TECHNICAL	SERV	/ [C	CE BULLI	ETIN			
DATE ISSUE	ED	MODEL YEAR(S) AF	FECTED		Model(s) Aff	ECTED		T	SB#
10/11/201	3	2013 & 201	4		King Aire, Es				407
10/11/201	.5	2013 & 201	т		Mountain A	Aire			TO 1
		BRAND)					T	YPE
All		American Star]	Mountain Aire	\boxtimes	Α	11 🗖	ТТ
Cypress		Dutch Star]	Kountry Aire		Б	w 🗆	САП
Northern Star		Kountry Star]	Essex	X			
Scottsdale		King Aire	X]	London Aire		D	PΣ	DB⊠
All Star ME		Ventana			Bay Star				
□ Air Conditi	oning &	z Heating	[Electrical Comp	onents			
☐ Appliances	& Acce	essories	Ι		Exterior Compo	onents			
☐ Cabinets &	Furnitu	ire	[Interior Compos	nents			
☐ Chassis Co	mponer	its	[Plumbing & Bat	h Compo	one	nts	
☐ Construction	on Com	ponents		X	Windows, Awni	ngs, Ven	ts, d	& Doors	3
		DESCR	RIPTION OF	Pi	ROBLEM				
Girard Systen	ns has d	etermined that certain n white connector			quipped with a 12v susceptible to rust.		on	sensor u	tilizing a
The units offer	stad ara	Girard G2000 and Nov	ya Awainas e	mat	outactured Septem	shar 2012) to	Santam	her 2013

G-2000/NOVA AWNING (ECO) ENGINEERING CHANGE ORDER

12 Volt Motion Sensor Upgrade Announcement

INSTALLATION INSTRUCTIONS FOR:

Figure 1

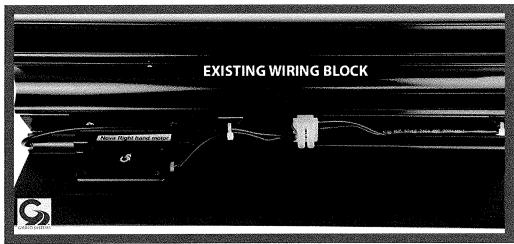
- A. Locate the wiring block that is supplying the motion sensor and led lighting system 12V power (if present). This should be located on the far right or far left side of the awnings' Lead Rail. (Figure 1)
- B. Make sure the 12V power has been shut off.
- C. Cut cable ties and remove wires from the existing wiring block making sure not to damage or cut any wires. Remove screws retaining the wiring block, and make sure to discard screws and old wiring block.

Figure 2

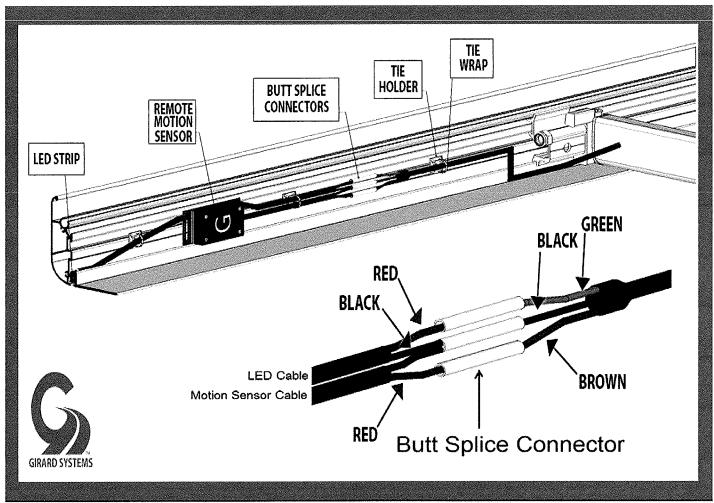
- L. Continue to the Motion Sensor and LED Lights wiring (if present). Make connections according to Figure 2. Ensure all connections are secure and tight.
- M. Return the 12V Power to the coach and test the Motion Sensor by shaking the Lead Rail of the awning; the awning should retract. Test the LED LIGHTS (if present).
- N. Once all connections have been made and tested, remove the 12V Power. Apply a heat source to the connectors to activate the thermal ends. The material should snug around the wire creating a waterproof seal.

Figure 3

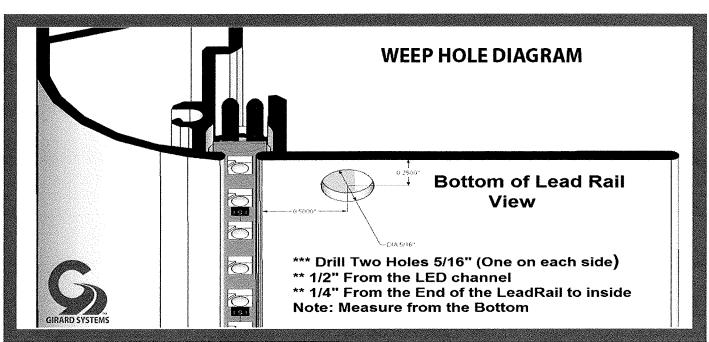
- A. Ensure that the 12V Power is OFF.
- B. Drill 5/16" hole on each end of the NOVA Awnings' Lead Rail. Drill from the bottom side of the Lead Rail. Ensure that a sharp drill bit is used.

Figure 3

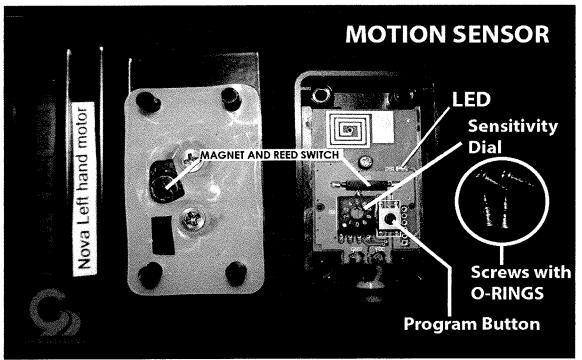
NOTE: THE O-RINGS ARE A CRITICAL PART OF THE NEW MOTION SENSOR AND MUST BE USED (Figure 3).

- C. Locate the Sensitivity Dial and carefully adjust to the #5 Position (Figure 3).
- D. Place the Motion Sensor cover upside down and back onto the base (Figure 4). The reed switch must be located directly over the magnet to operate the Motion Sensor.
- E. Apply a 12V Power Source to the 12V Motion Sensor. The Purple LED will turn on solid and then will flash intermittently. The Motion Sensor is now ready to program.
